Design Revisions – Proposal Revision D

The following key design changes have been made to satisfy the Planning Authority, following detailed feedback on Revision C of the Design Proposal previously submitted.

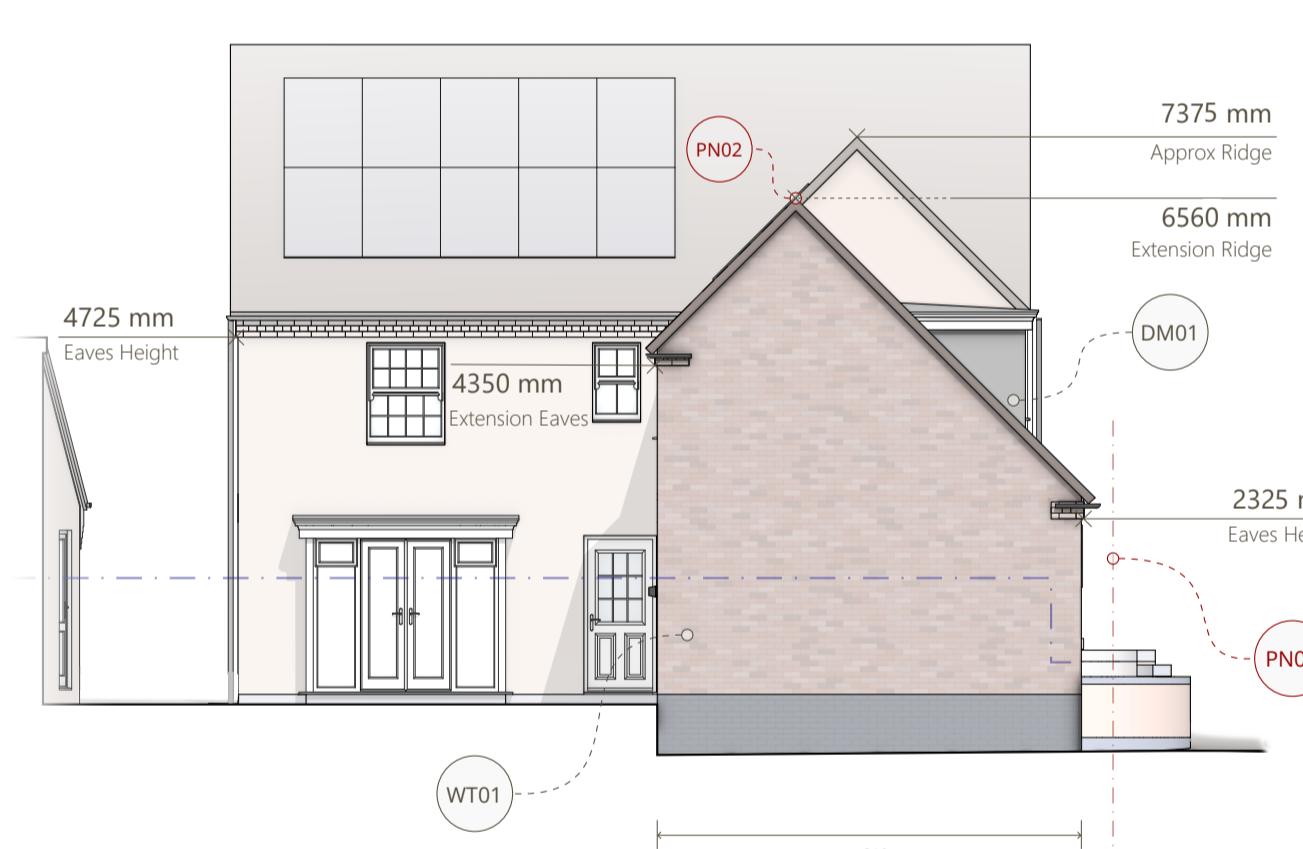
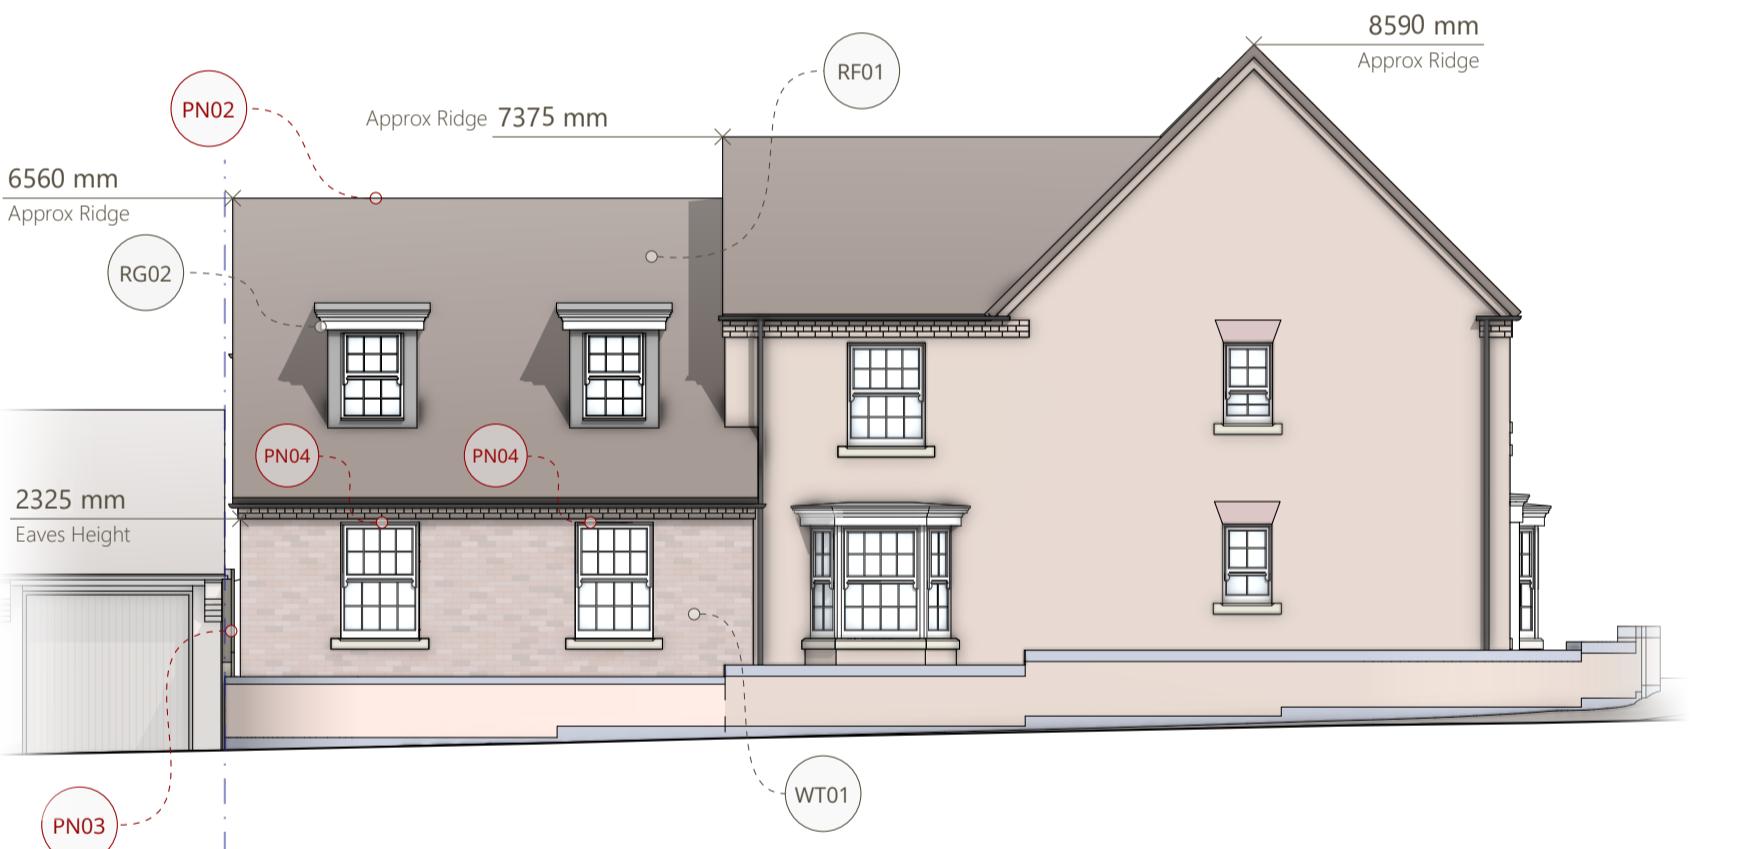
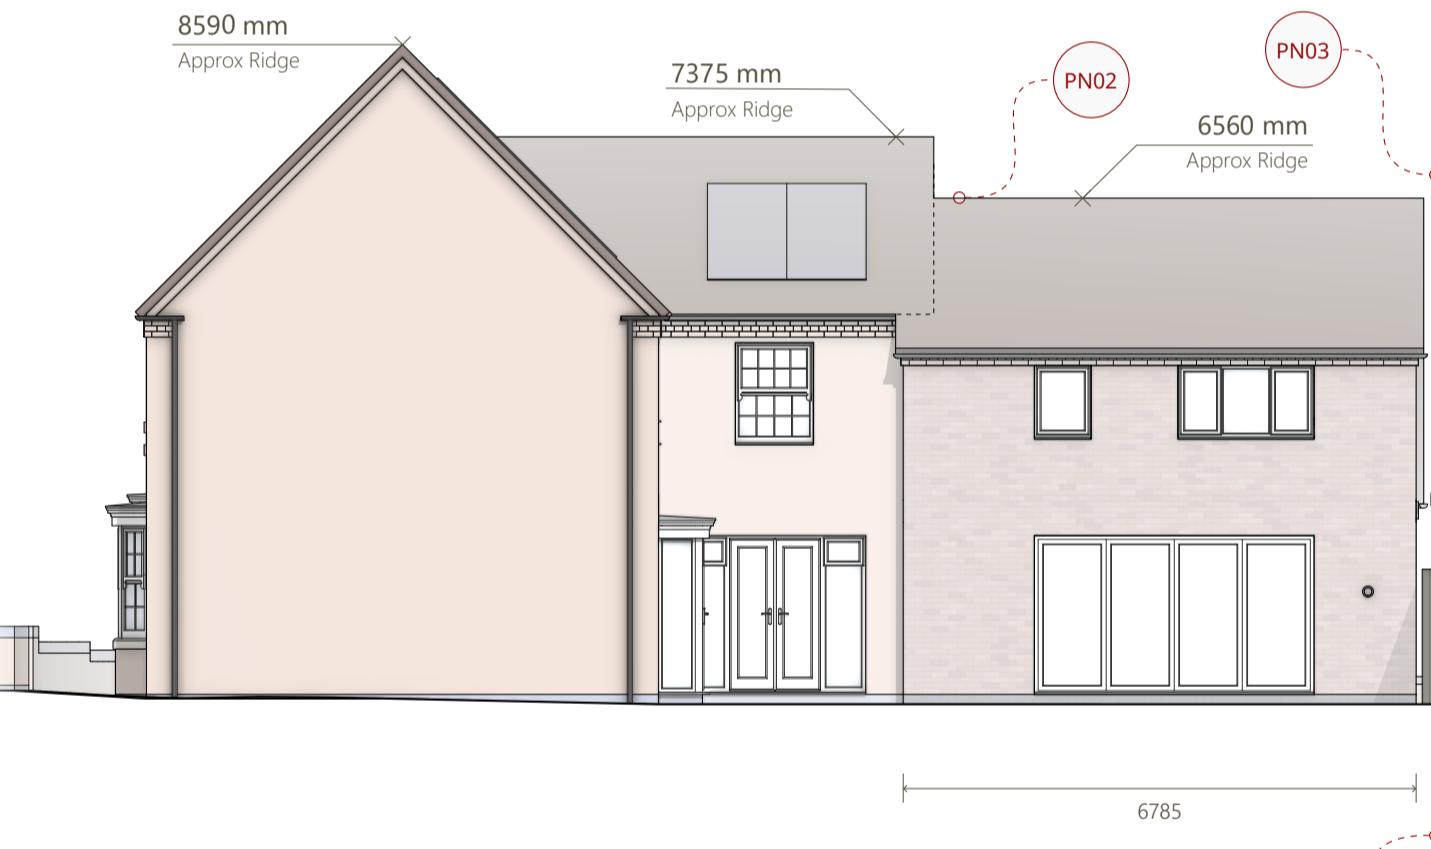
- The planner requested further consideration of the extension's mass in relation to the host dwelling.
- We were advised to reduce the projection depth into Beldover Drive.
- It was recommended to focus on reducing the dominance of the new addition over the existing building and streetscape.
- Further reductions in the ridge height were advised, building upon feedback from the previous two design proposals.
- It was suggested to reduce boundary impact to address the neighbour's concerns regarding potential undermining impacts during the extension's construction.

The building line has been set back by 450mm along Beldover Drive, creating a more sympathetic massing in line with the Planning Officer's feedback. This adjustment significantly softens the extension's impact on both the host dwelling and the surrounding streetscape.

The roof and upper-level interior spaces have been redesigned, enabling a 450mm reduction in ridge height. While this change necessitates compromise on internal layout and reduces first-floor ceiling heights, the client accepts these constraints to achieve a more neighbourly form. This reduction aligns more closely with planning recommendations and helps the extension blend more harmoniously into its setting.

The gabled end wall now steps in from the neighbouring boundary by an extra 100mm, allowing the original boundary fence to be reinstated. This ensures the extension's foundation will not disturb the neighbour's property. In doing so, the revised proposal respects the neighbour's comments submitted to the case officer and addresses this concern.

Due to the lowered eaves, the previously proposed flat arch lintel detail would be largely obscured by gutters. Removing this contrasting element ensures the extension remains discreet and visually unobtrusive. With this revision, attention remains focused on the main dwelling, rather than the contrasting brickwork element leading the eye toward the extension as before, thus decreasing the overall visual presence of the extension.
